**RE: St Joseph on the Rio Grande Church
5901 St Joseph Dr NW
Conceptual Grading and Drainage Plan
Engineer's Stamp Date: 6/12/18
Hydrology File: G11D014A**

Based on the information provided in your submittal received on 6/12/18, the Conceptual Grading and Drainage Plan is approved for Site Plan for Building Permit.

ST. JOSEPH'S ON THE RIO GRANDE NAZARETH CENTER
SITE GRADING & DRAINAGE
Basin and Drainage Plan

Re: G11D014A - Church of St. Joseph on the Rio Grande – Conceptual Grading and Drainage Plan

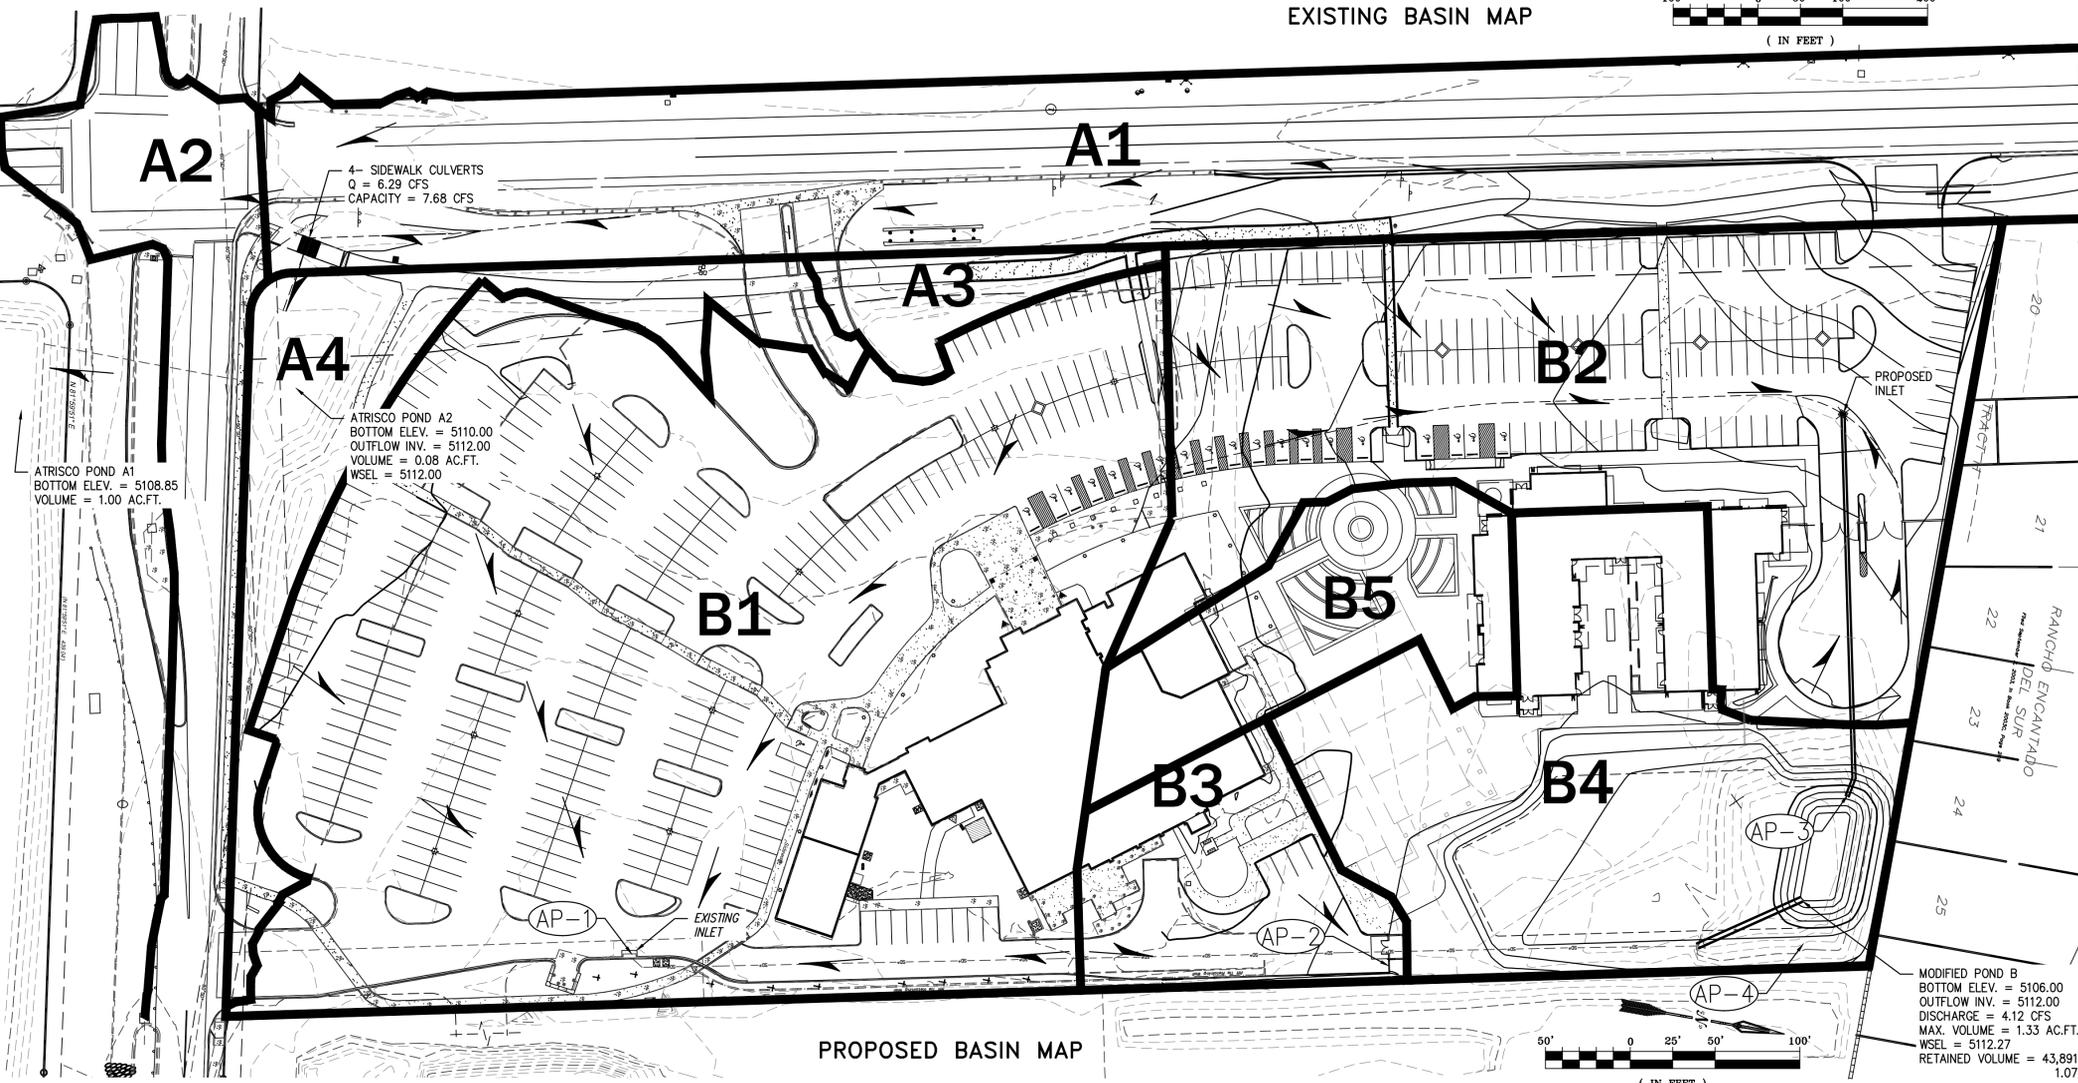
- 1. Use sidewalk culverts, not a dip section, to convey flows from the Atrisco ROW across the bike path/sidewalk. Size for the 100-yr runoff and include calculations..*

The requested modification has been made, and the culverts' capacity calculation is shown.

CITY OF ALBUQUERQUE
PUBLIC WORKS DEPARTMENT
ENGINEERING DEVELOPMENT GROUP
ST. JOSEPH'S ON THE RIO GRANDE NAZARETH CENTER
SITE GRADING & DRAINAGE
CONCEPTUAL GRADING PLAN

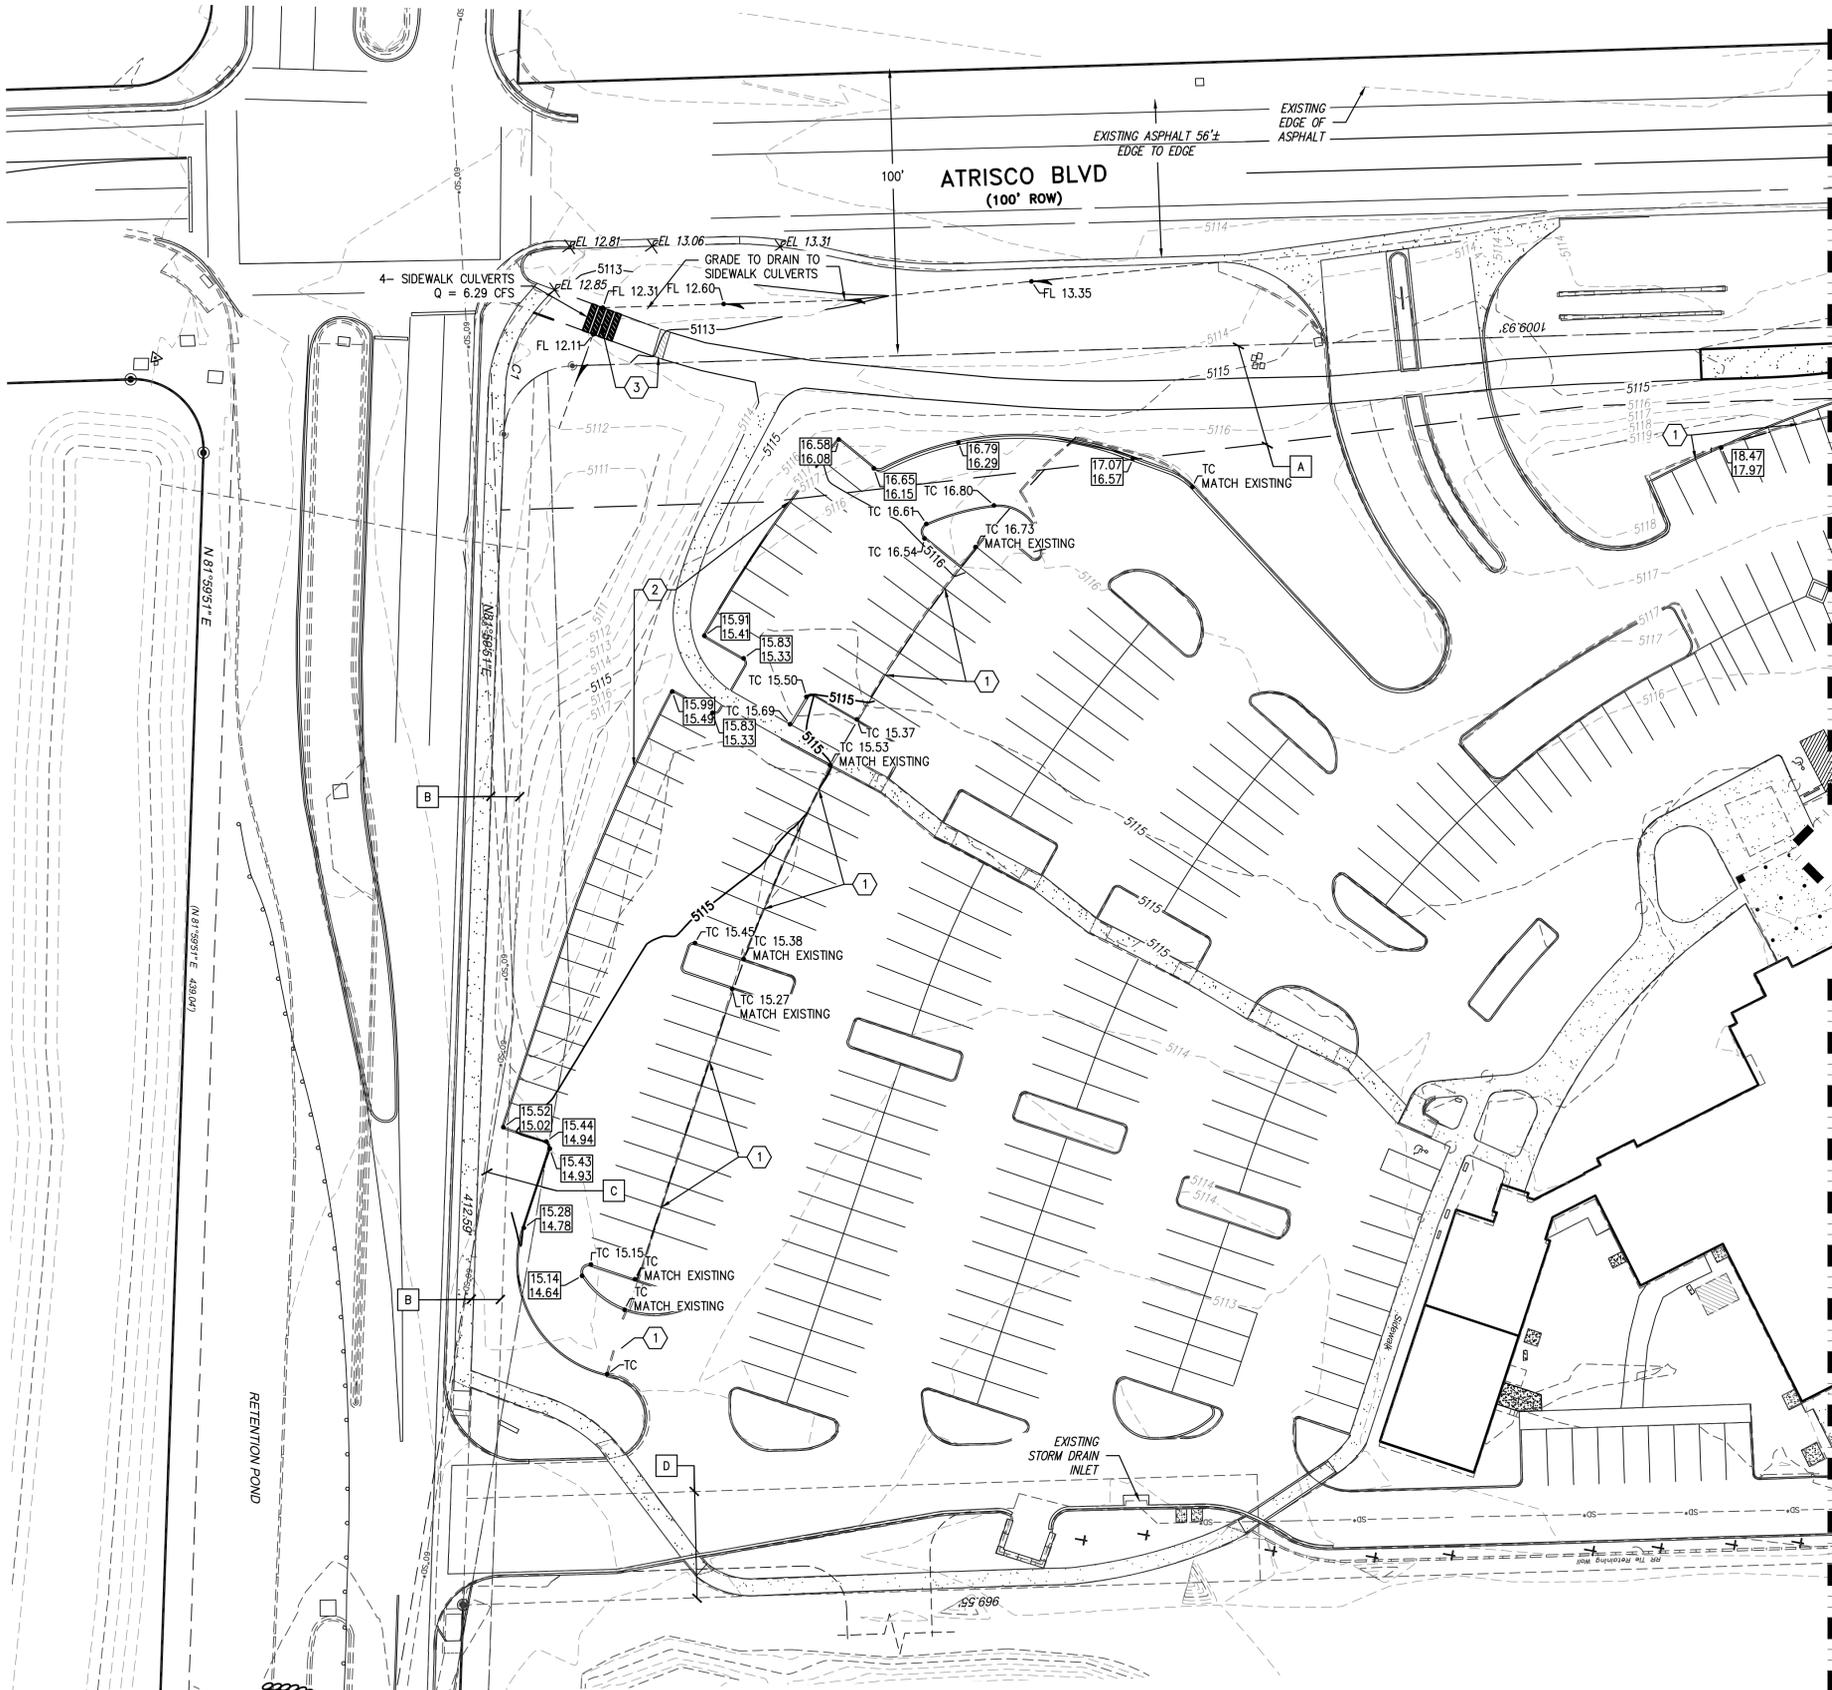
1. The sidewalk culverts will need to call-out std dwg 2236 and provide the culvert width; the diamond plates will need to be extended 1' past edge of sidewalk to avoid a drop-off. Because this is work in the ROW, no adjustments to the private grading plan are needed, but the work order plans will need to show these corrections.

- Madeline Carruthers (mtafoya@cabq.gov, 924-3997) regarding the routing and recording process.
6. This project requires an ESC Plan, submitted to the Stormwater Quality Engineer (Curtis Cherne PE, ccherne@cabq.gov or 924-3420).
 7. Provide invert-out elevation for both outfalls into the private pond.
 8. Provide an emergency spillways or 2x capacity for the private storm drain; this is applicable when the inlets are in a sump conditions. Provide supporting calculations for the chosen options.
 9. Additional comments can reasonably be expected at Building Permit, based on the outcome of the above remarks and level of detail shown on plans.
 10. The resubmittal fee for this drainage submittal is: \$150.
